FINAL PLAT  
**KILLENWOOD POINTE ADDITION**  
AN ADDITION TO WICHITA, SEDGWICK COUNTY, KANSAS

RE: SUB 2000-21 – Final Plat of KILLENWOOD POINTE ADDITION

RE: SUB 2000-21 -- Final Plat of KILLENWOOD POINTE ADDITION

**CASE NUMBER:** SUB 2000-21 -- KILLENWOOD POINTE ADDITION

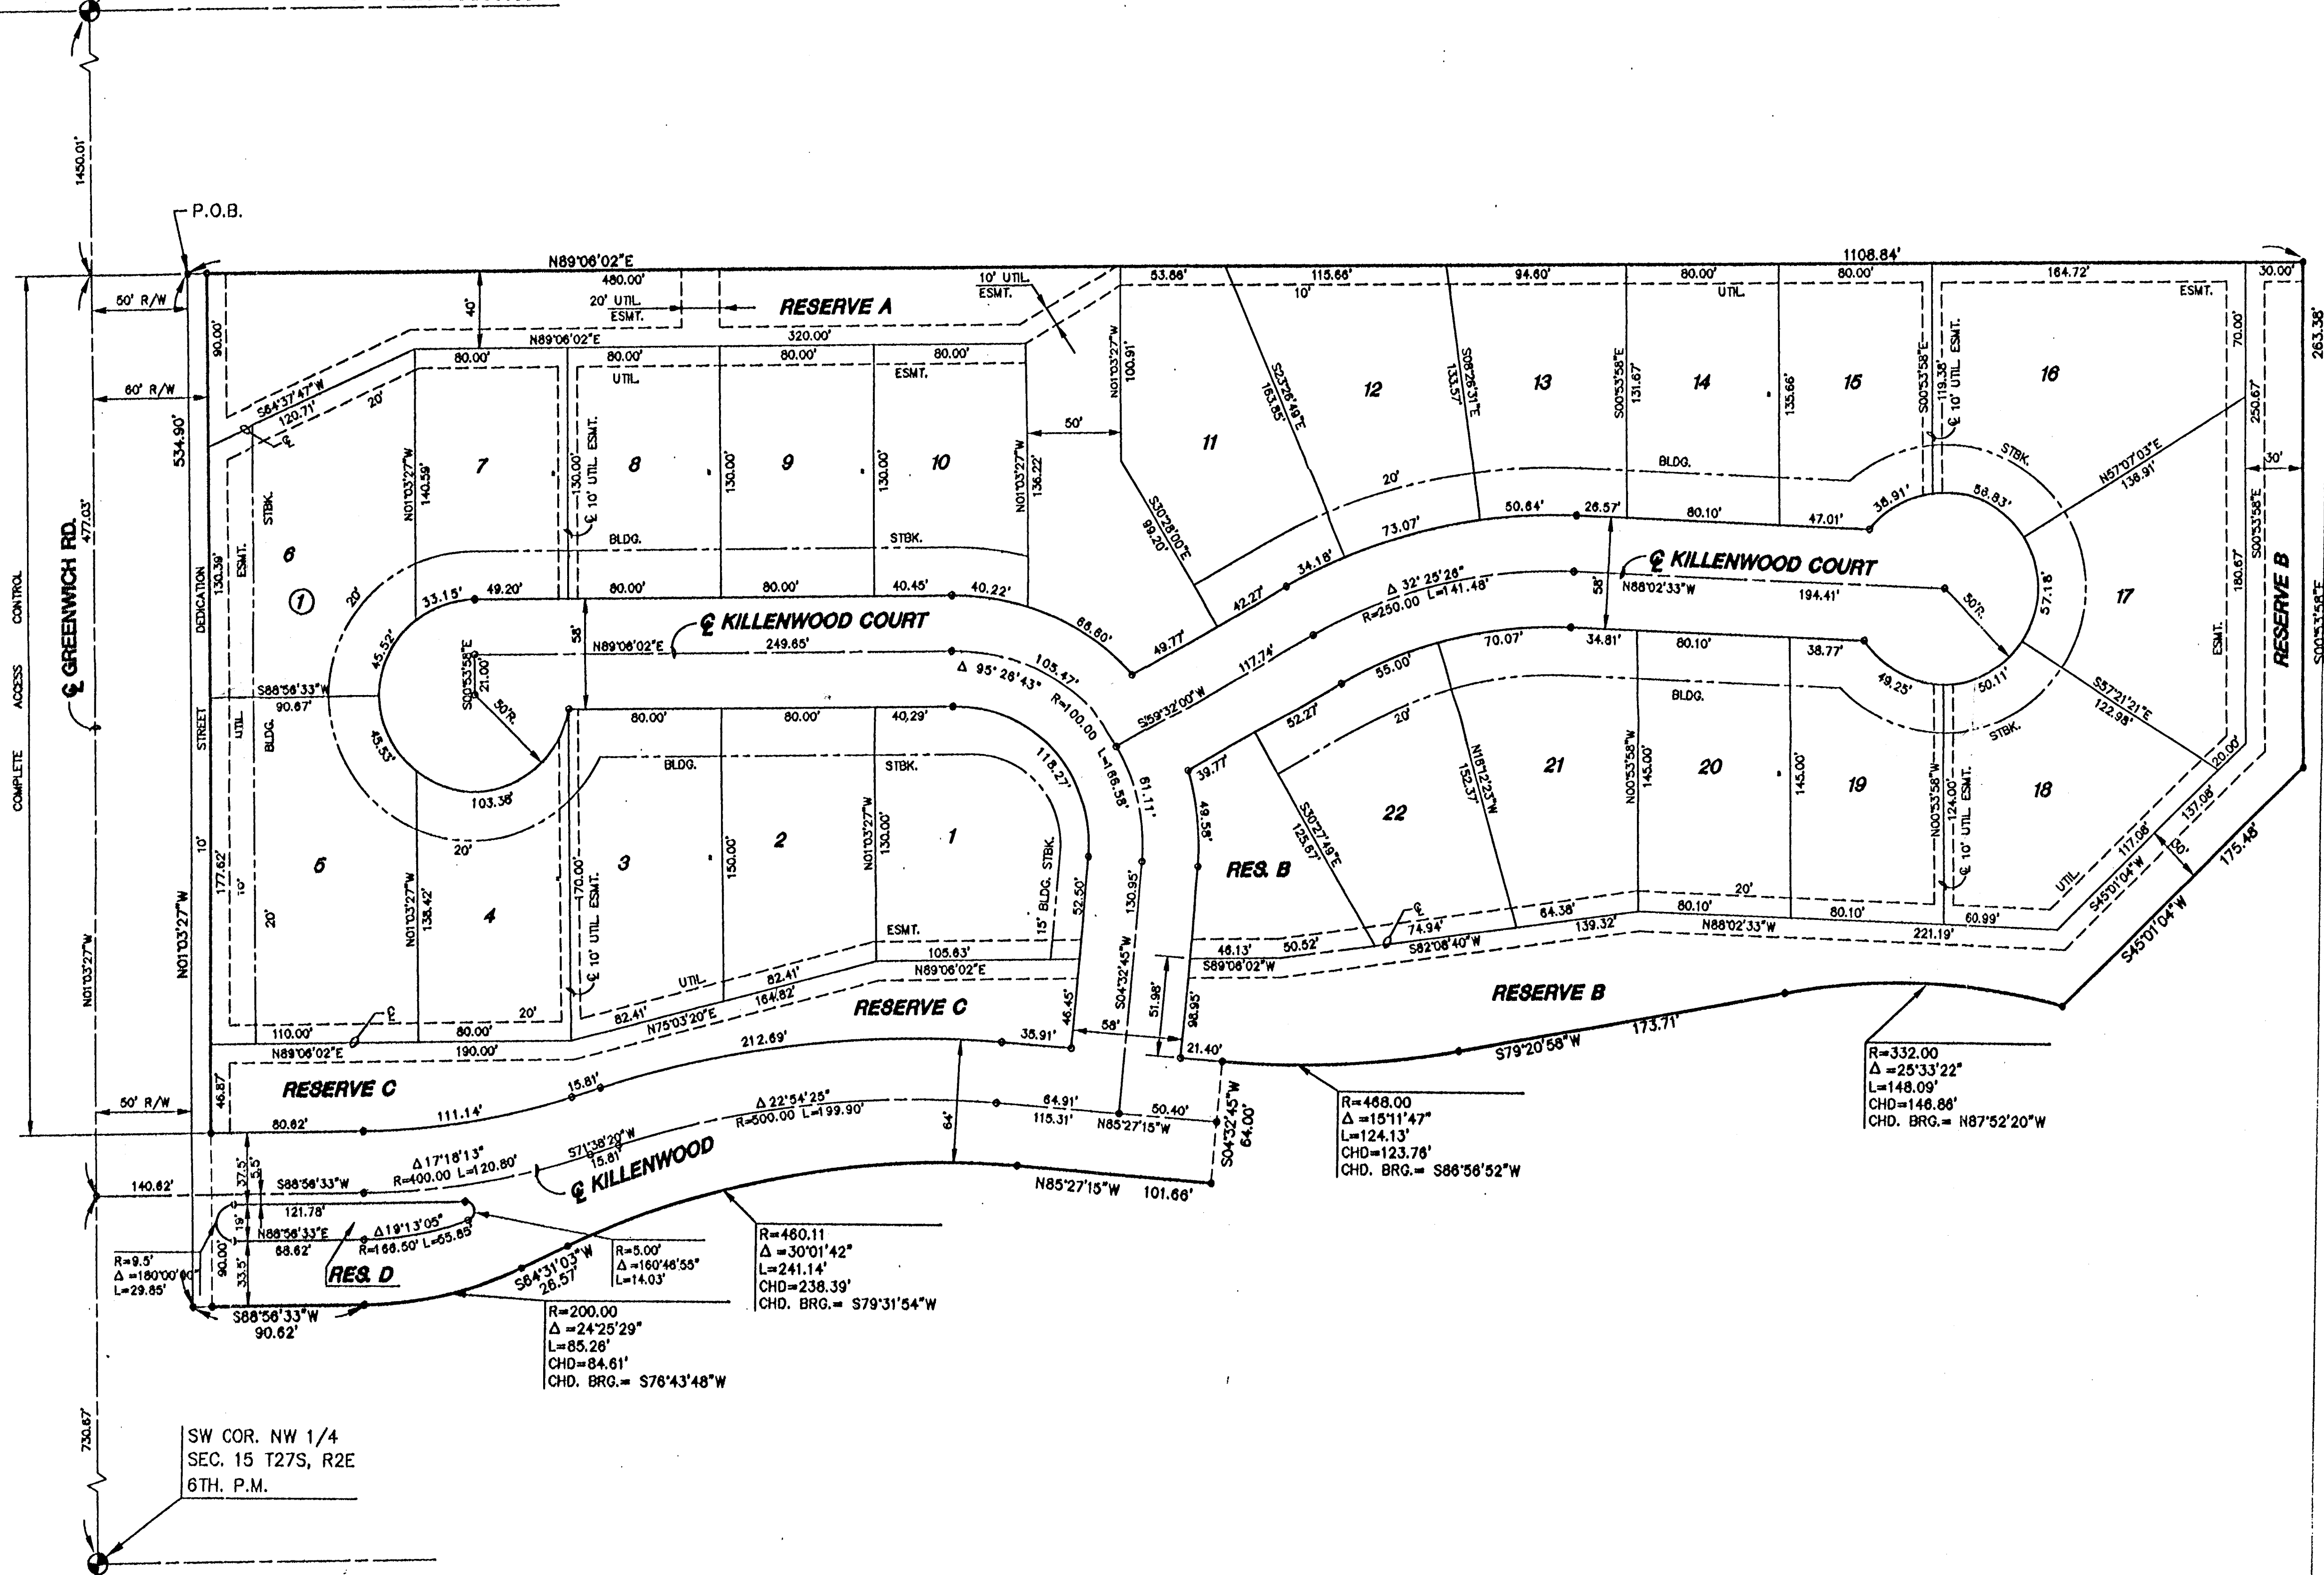
- E. **County Engineering** needs to comment on the need for additional right-of-way along Greenwich. **10-foot of additional right-of-way shall be dedicated along Greenwich.**

- H. The plat shall denote complete access control along the site's frontage to Greenwich.
- I. The Applicant is reminded that a platting binder is required with the final plat. Approval of this plat will be subject to submittal of this binder and any relevant conditions found by such a review.

- L. The applicant shall guarantee the paving of the proposed streets.
- M. The owner's signature block should reference "Killenwood Pointe" Addition.
- N. The MAPC signature block should reference Frank Garofalo as the Chairman.

- O. The southwest tie point should reference Section 15, Township 27 South.
- P. The applicant shall submit a covenant which provides for four (4) off-street parking spaces per dwelling unit on each lot which abuts a 58-foot street. The covenant shall inventory the affected lots by lot and block number and shall state that the covenant runs with the land and is binding on future owners and assigns.

- E. **County Engineering** needs to comment on the need for additional right-of-way along Greenwich. **10-foot of additional right-of-way shall be dedicated along Greenwich.**

- G. **City Fire Department** needs to comment on the plat's street names. **The plat's street names are approved.**
- H. The plat shall denote complete access control along the site's frontage to Greenwich.

- M. The owner's signature block should reference "Killenwood Pointe" Addition.
- N. The MAPC signature block should reference Frank Garofalo as the Chairman.

- O. The southwest tie point should reference Section 15, Township 27 South.
- P. The applicant shall submit a covenant which provides for four (4) off-street parking spaces per dwelling unit on each lot which abuts a 58-foot street. The covenant shall inventory the affected lots by lot and block number and shall state that the covenant runs with the land and is binding on future owners and assigns.

The requested dedication has been denoted on the final plat.
- F. **County/City Engineering** needs to comment on the status of the applicant's drainage plan. **The Applicant shall coordinate the removal or modification of terraces on the site with NRCS. City Engineering requests an off-site drainage easement.**
- G. **City Fire Department** needs to comment on the plat's street names. **The plat's street names are approved.**

The requested dedication has been denoted on the final plat.
